South King Fire and Rescue Station 67 Interior Improvements

ADDENDUM #1

December 7, 2016

A20.01

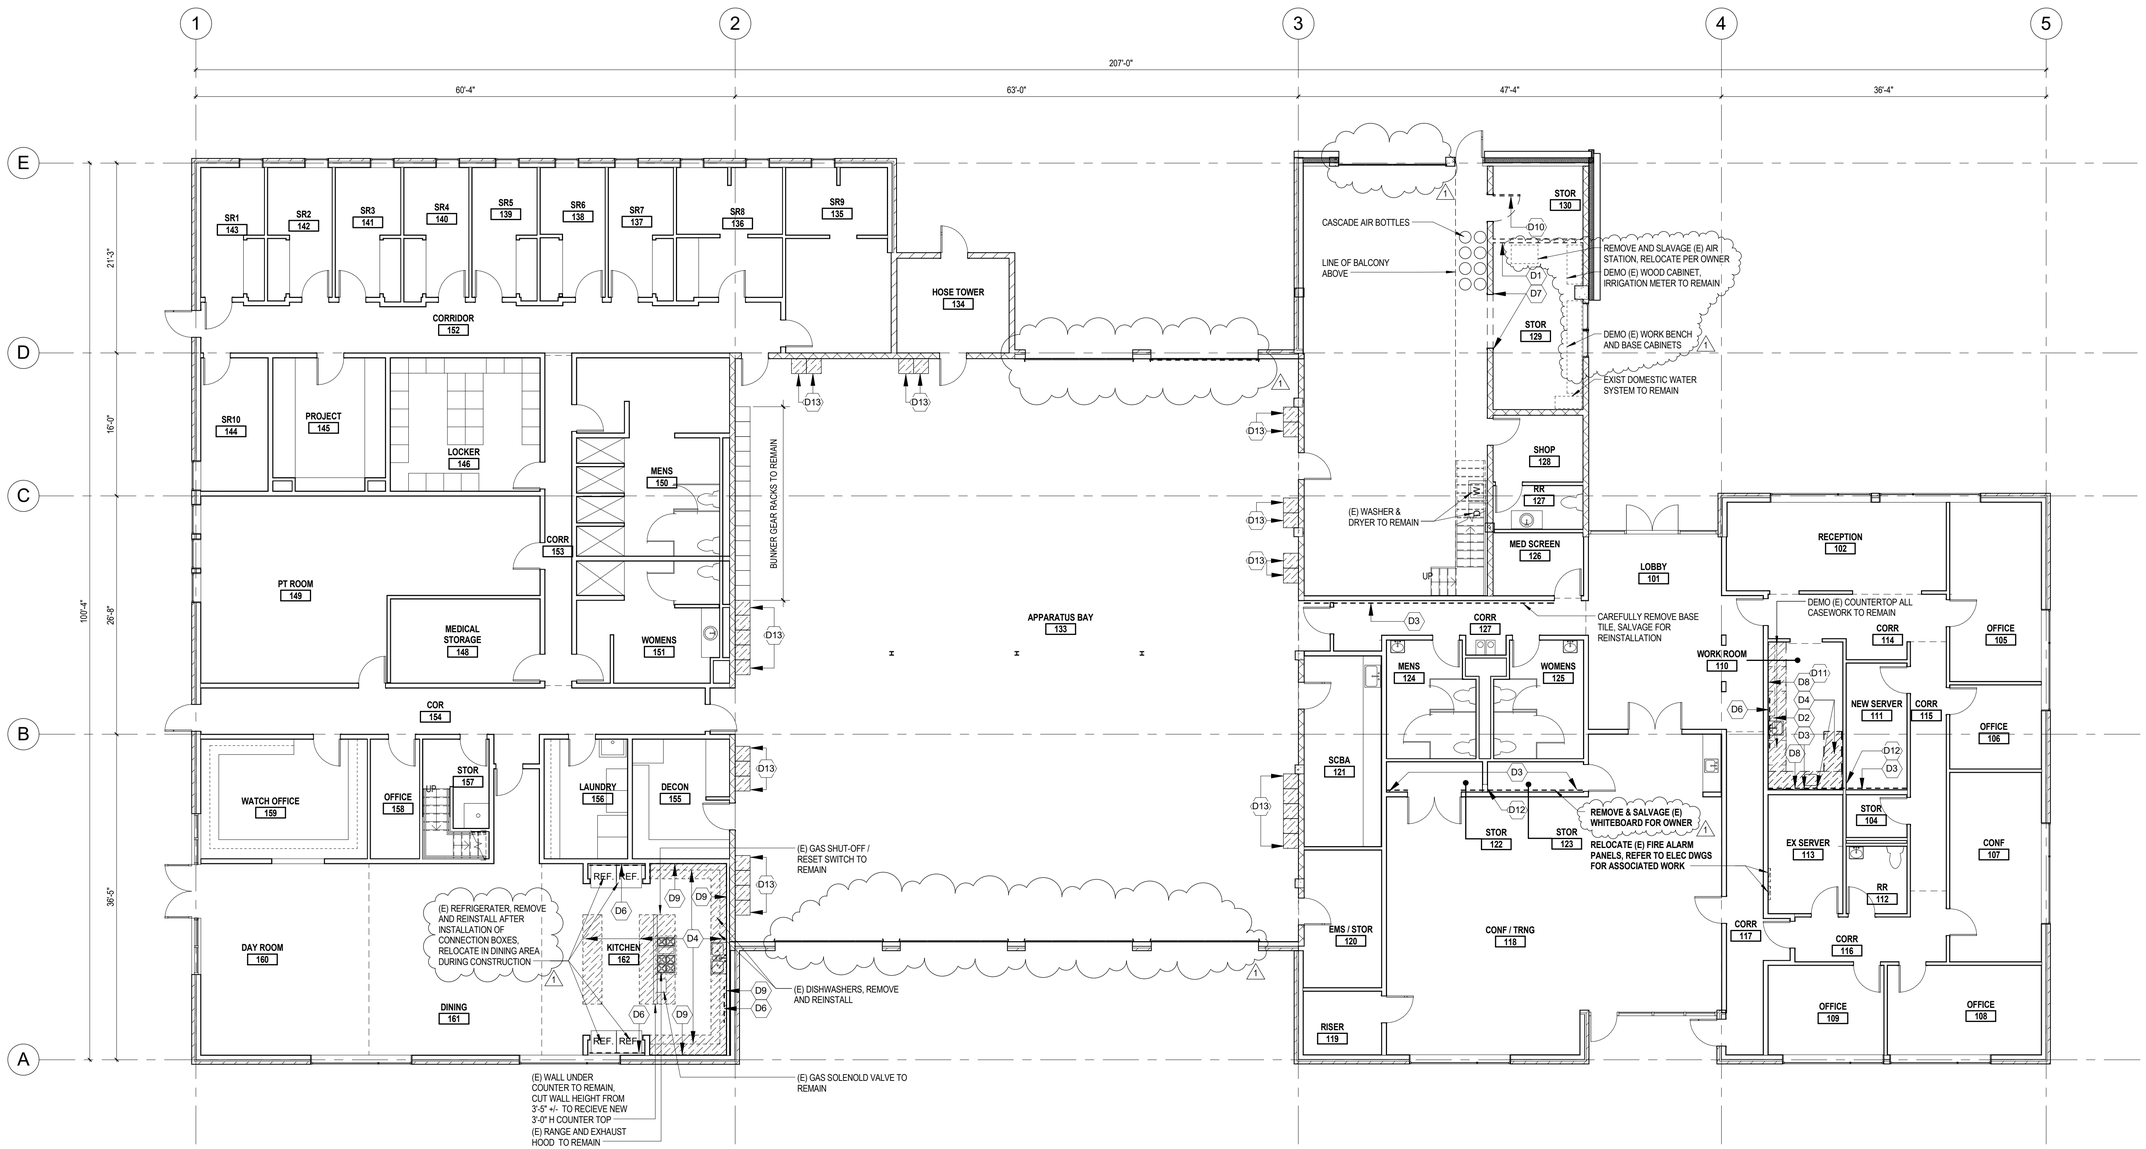
ITEM 3.	A20.01	See clouded revisions on attached drawing.
ITEM 4.	A20.05	See clouded revisions on attached drawing.
ITEM 5.	A21.13	See clouded revisions on attached drawing.

SHEET # ASK.01

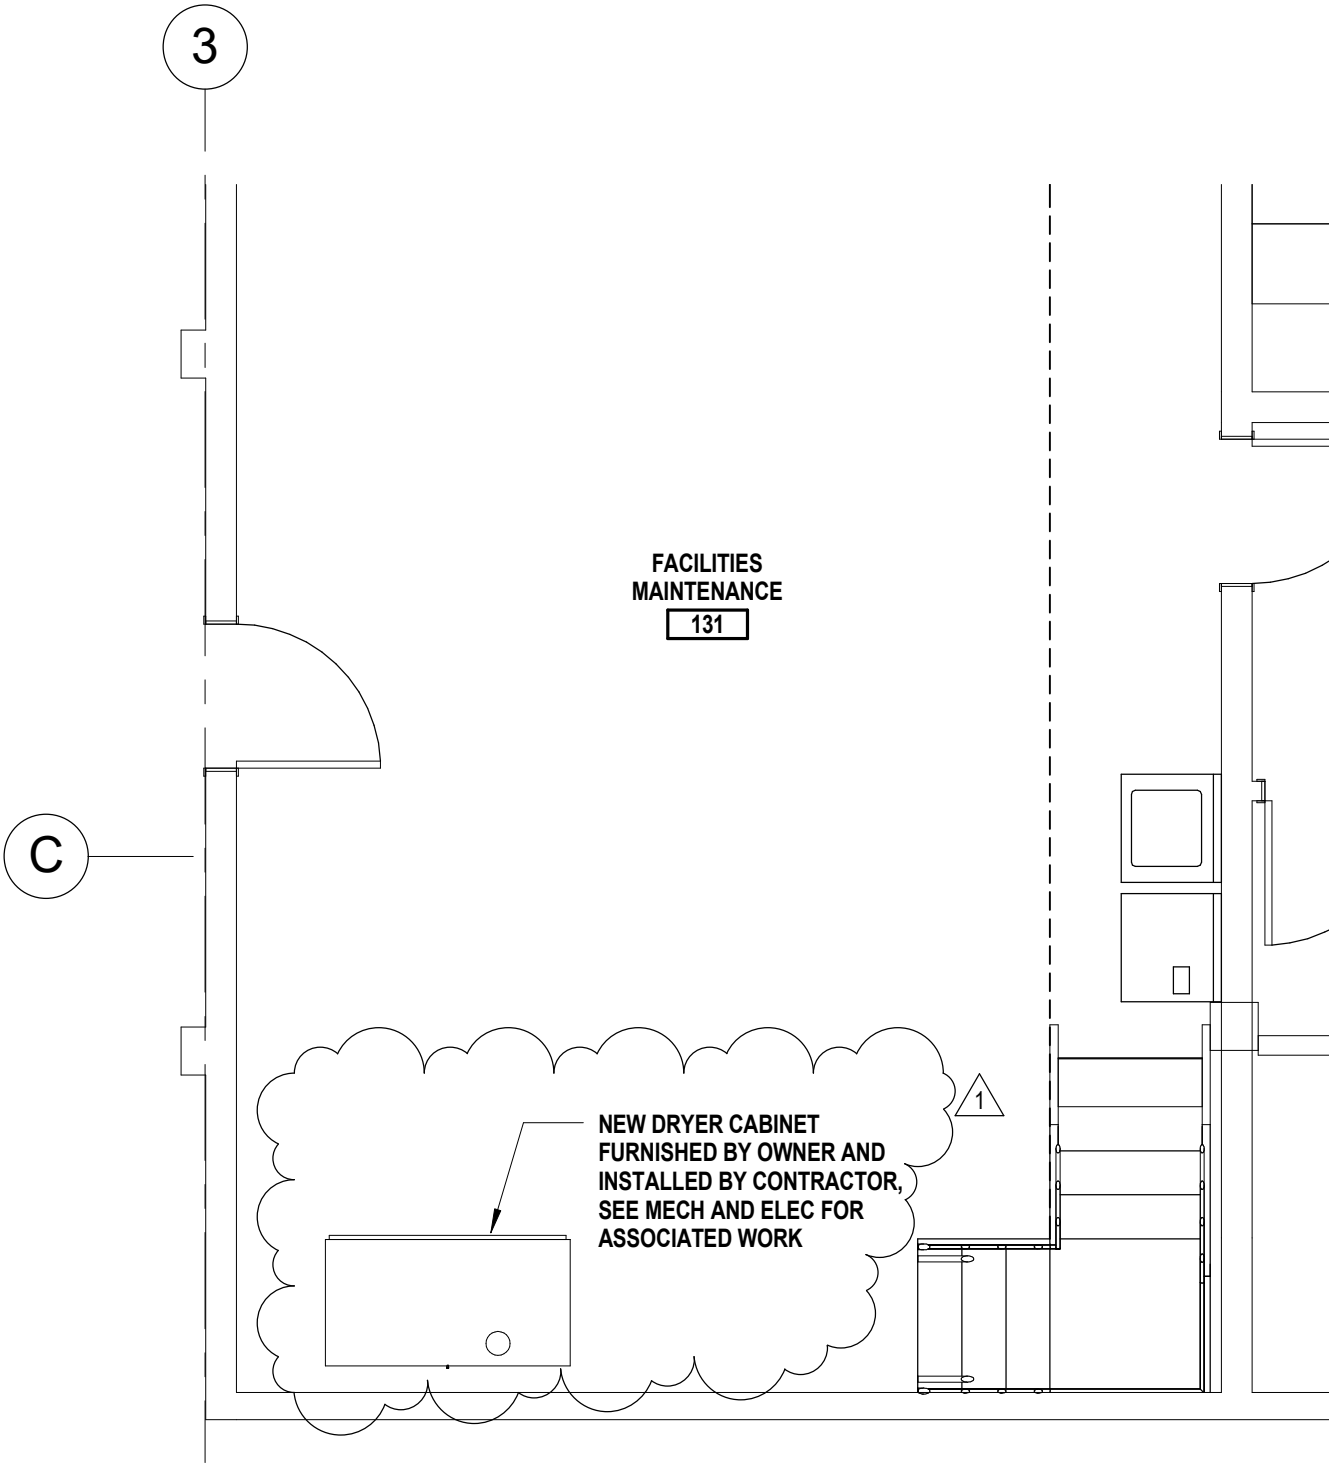
ITEM 9.	ASK.01	New dryer cabinet to be furnished by Owner and installed by

Contractor. See Mechanical and Electrical for associated work.

SHEET # ESK.01
LEVEL 1 - PARTIAL POWER PLAN

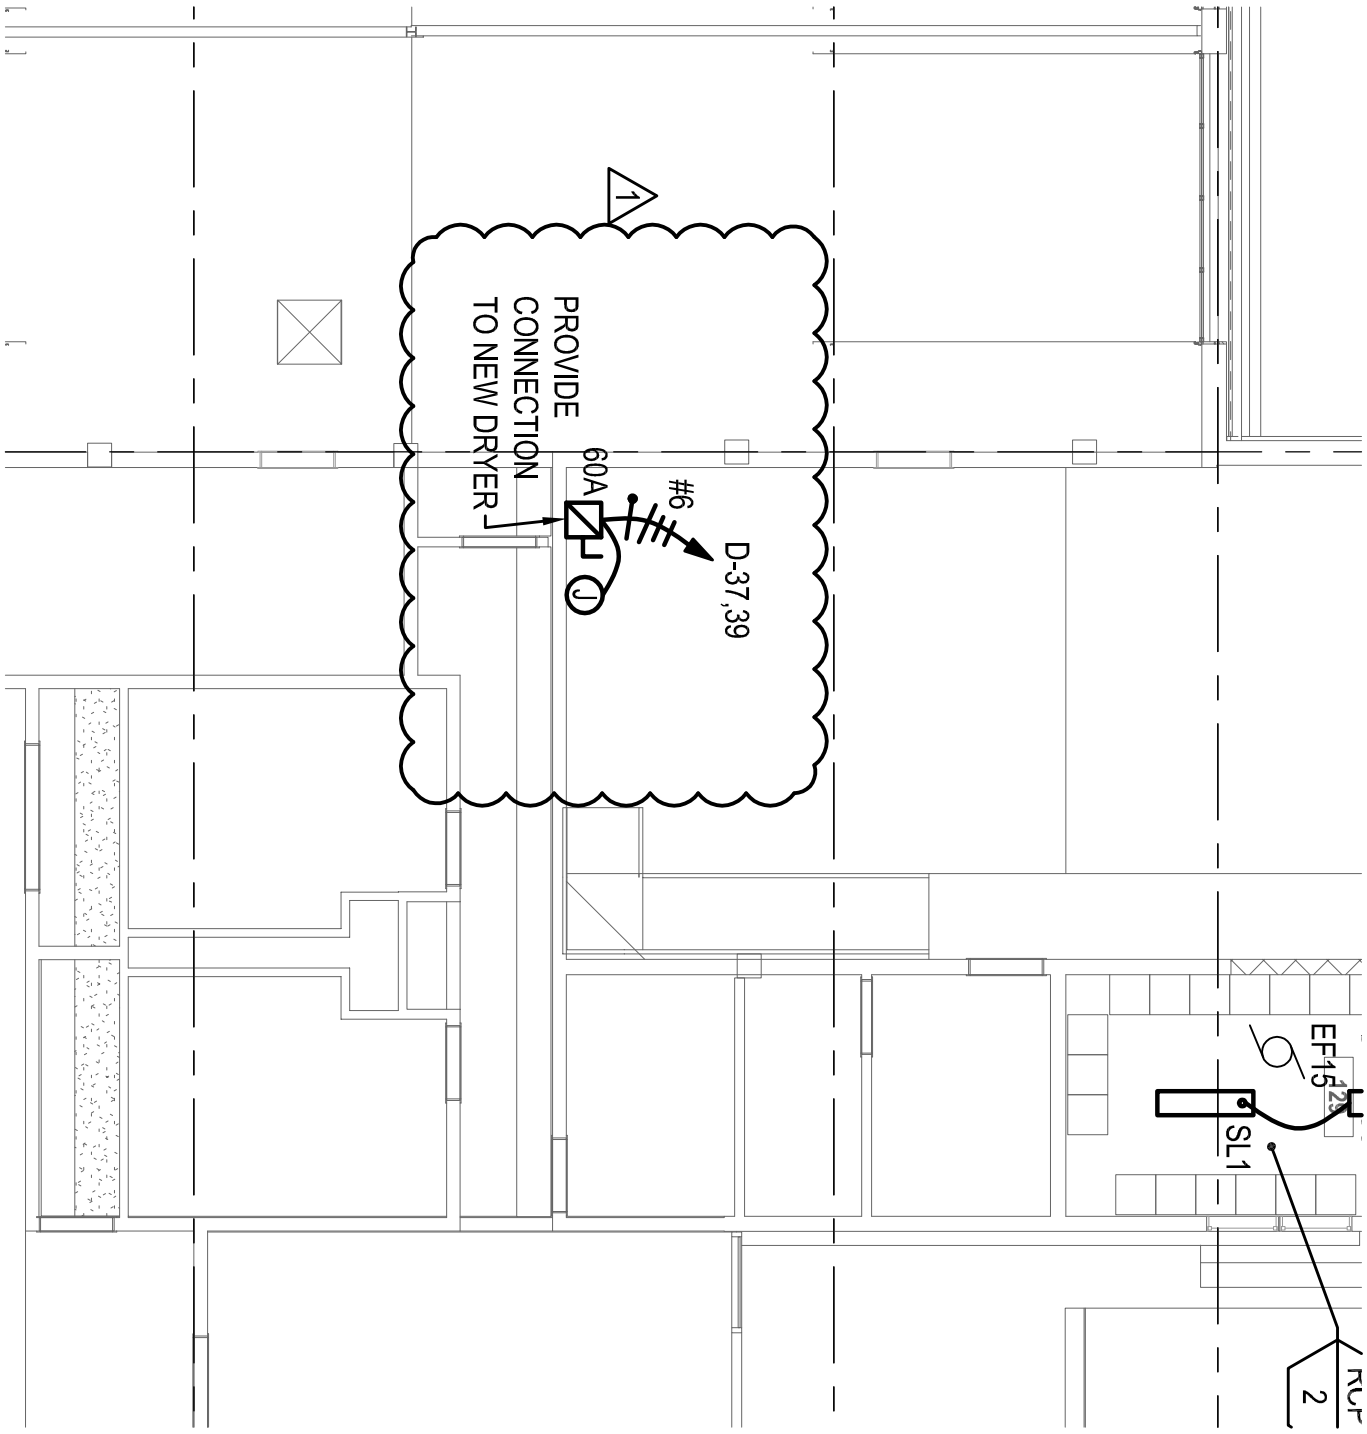
ITEM 10. ED1.12	DELETE demolition note 9. Existing overhead doors are to remain.
ITEM 11. E1.21	DELETE construction note 4. Existing overhead doors are to remain.
ITEM 12. ESK.01	New dryer cabinet added to Room 131 on the South Wall. Provide 60 amp disconnect switch (locate adjacent to the dryer) and a 1" C., (3) #6 and (1) #8 ground flexible connection to the equipment. Connect to Panel D – 37, 39 with 1"C. (3) #6 and (1) #8 ground.
ITEM 13. ESK.02	Provide a 60 amp – 2 pole circuit breaker in Panel D for the new dryer cabinet.

MSK-1

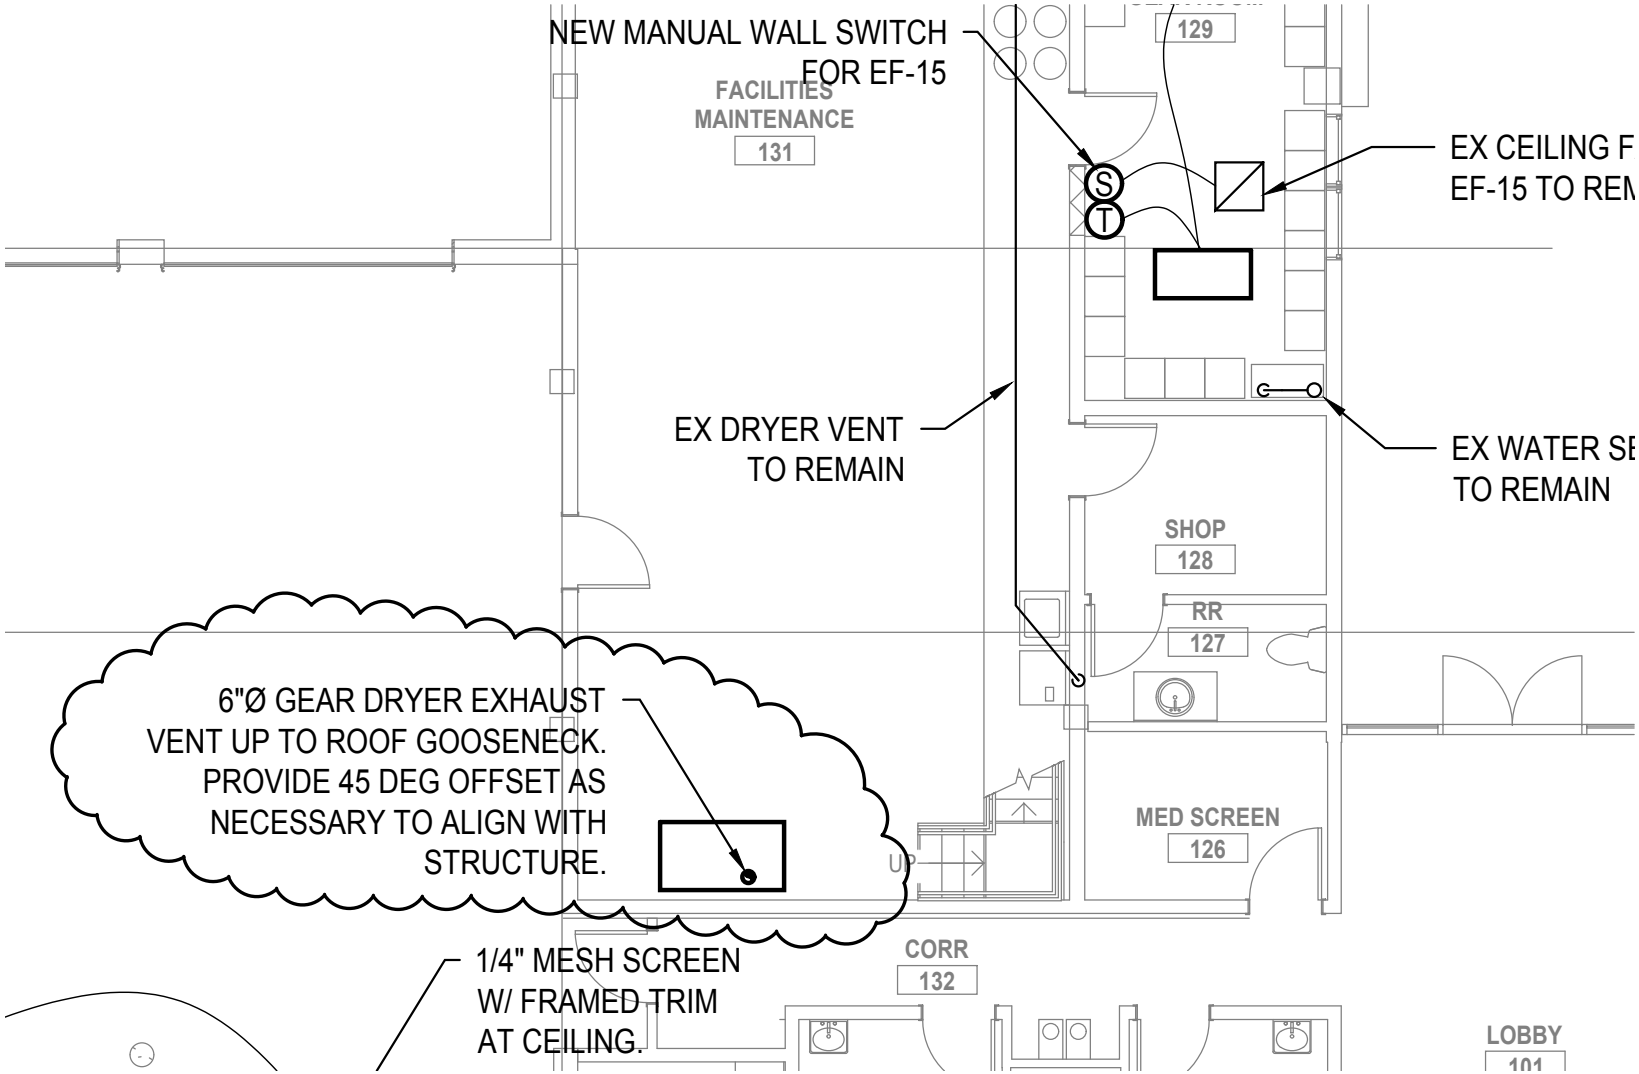
ITEM 14. MSK-1 MSK-2	Provide vent from bunker gear dryer.
ITEM 15. MSK-3	Gooseneck detail.

SHEET # 7 / S42.01
APP BAY ROOF FRAMING DETAIL

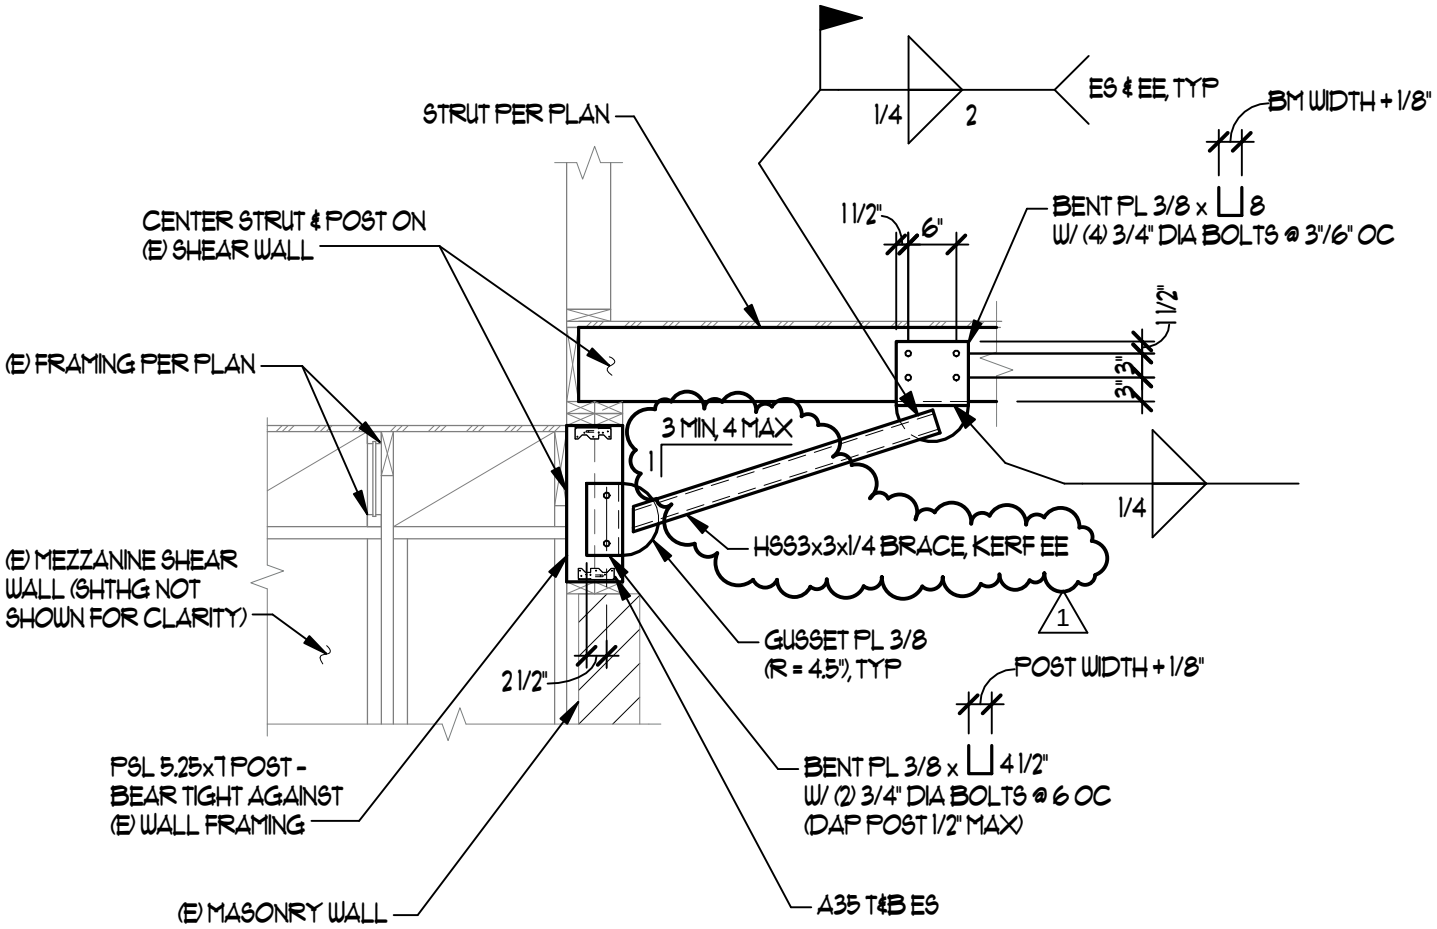
ITEM 16. S42.01	See clouded revisions on attached sketch.
